Subject: Duke Energy Corporation
Catawba Nuclear Station, Units 1 and 2
Docket Numbers 50-413 and 50-414
Proposed Technical Specifications Amendments
3.8.4, DC Sources - Operating
3.8.6, Battery Cell Parameters

MARKED-UP TS AND BASES PAGES FOR CATAWBA

DESCRIPTION OF PROPOSED CHANGES AND TECHNICAL JUSTIFICATION

GNB NCN-9 DG Battery Application

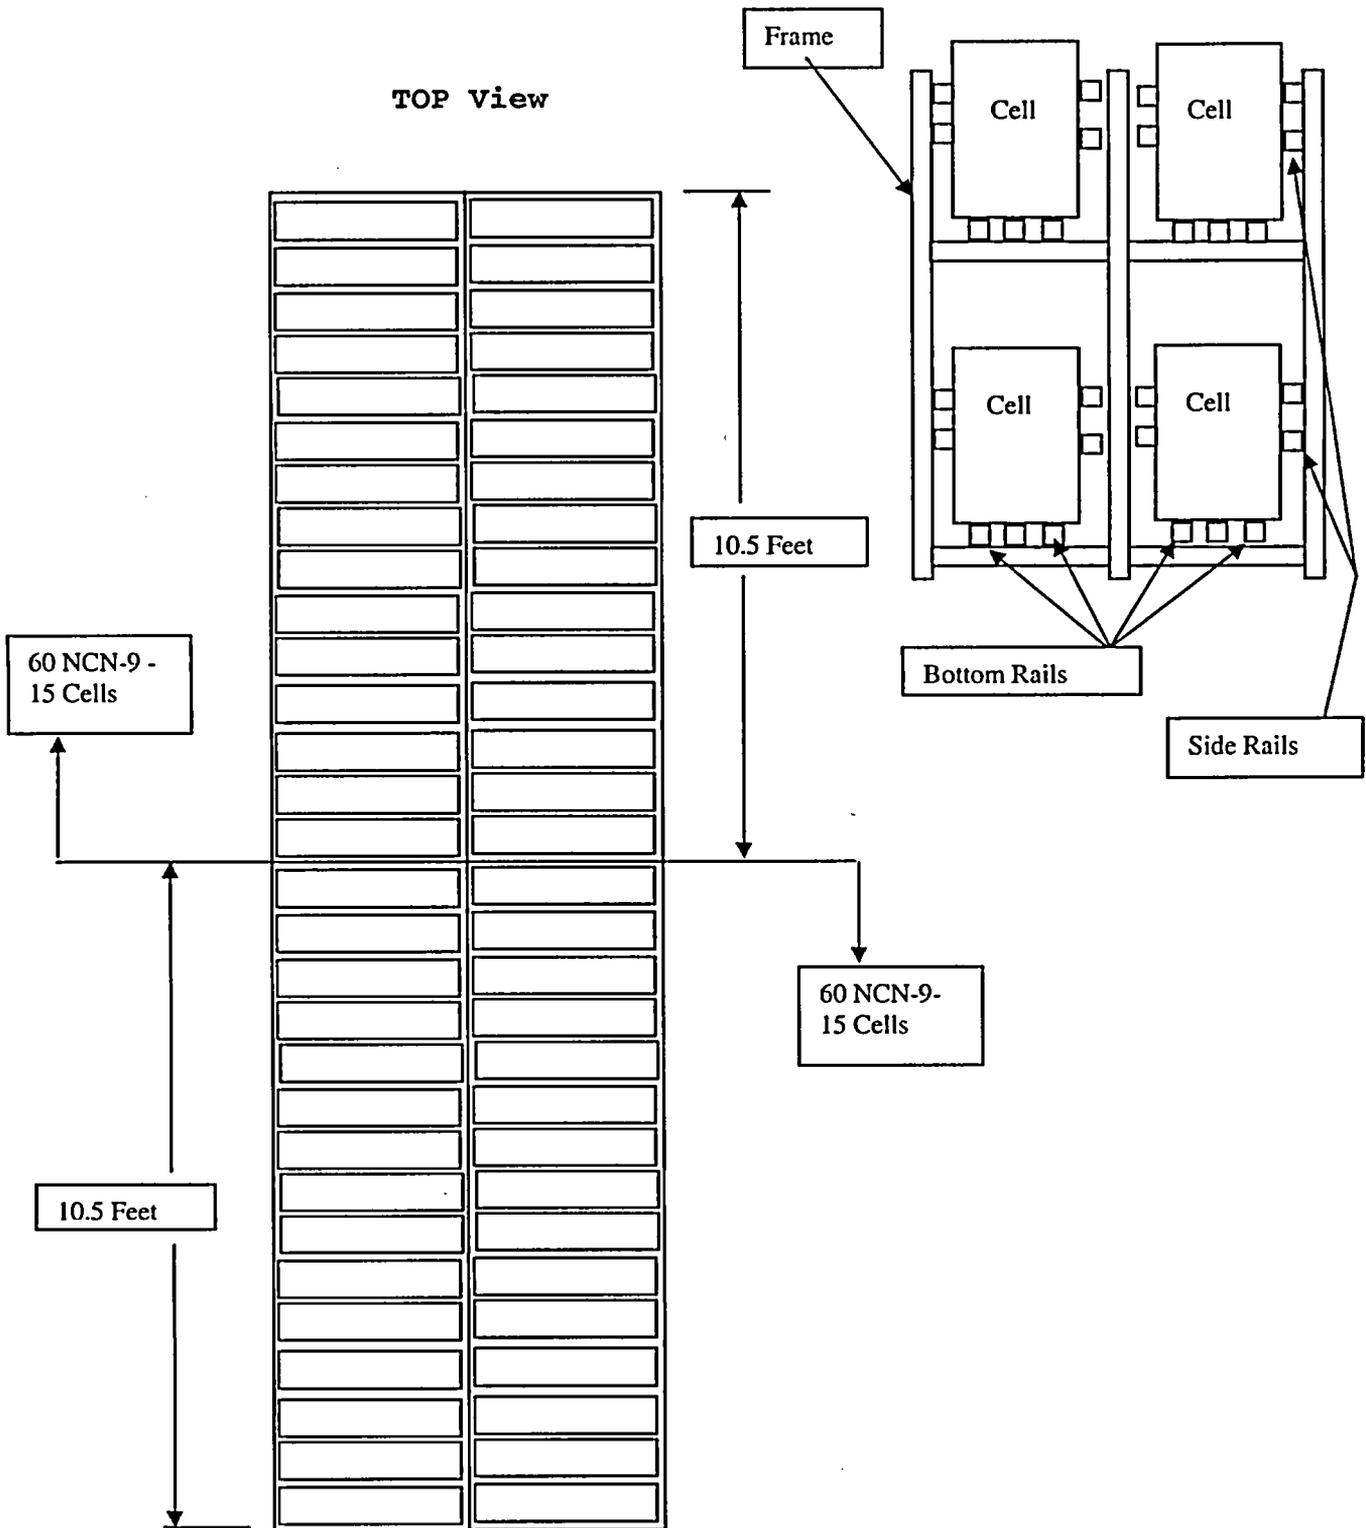
The GNB NCN-9 lead acid battery (refer to attached figure) has been selected for replacement of the existing DG nickel cadmium batteries. The NCN-9 cell type has 4 positive plates with a 688 amp-hour capacity based on an 8-hour rate to 1.75 volts/cell end voltage at 77F. The capacity of the new cells is sufficient to power their respective loads during a design basis accident for the required 2-hour duration. Based on the above discussion, the selected battery is large enough to supply the duty cycle

requirements with sufficient margin to allow for at least one cell to be jumpered out if necessary. The replacement batteries will consist of 60 cells each.
